PCN-20190112 TEB0911-04-* SPI Flash and eMMC Change

Company	Trenz Electronic GmbH
PCN Number	PCN-20190112
Title	TEB0911-04-* SPI Flash and eMMC Change
Subject	BOM change
Issue Date	2019-09-09

#3 Change R65 to 1K

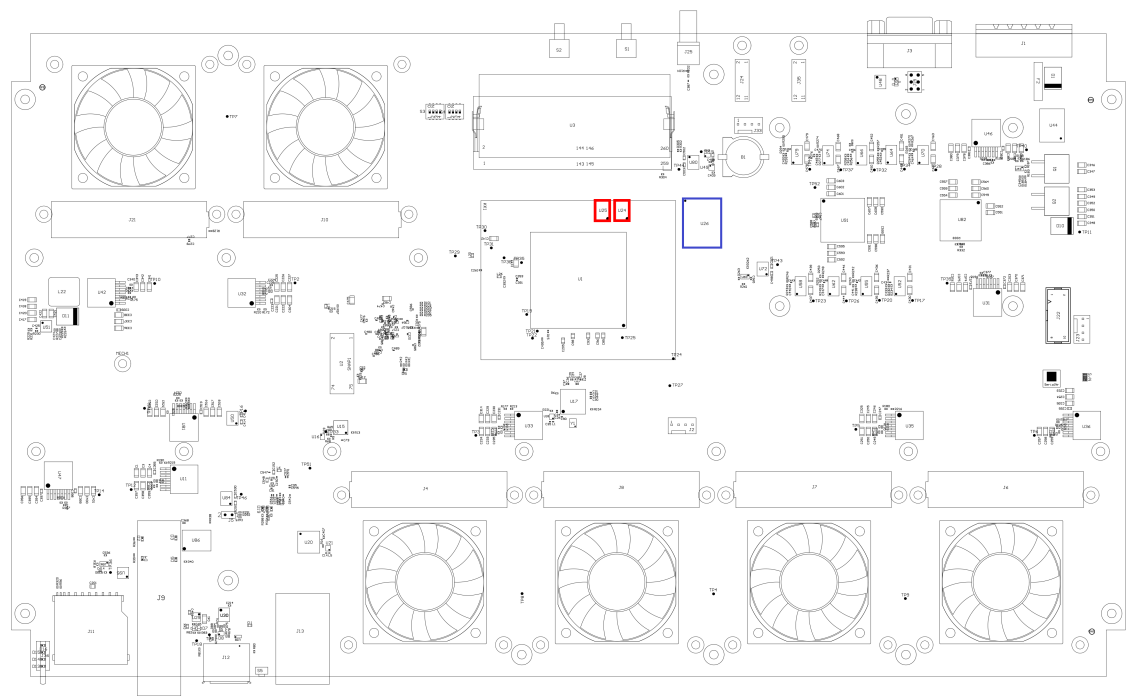
Type: BOM change

Reason: USB connection problem on some carriers reported

Impact: USB connection works reliable
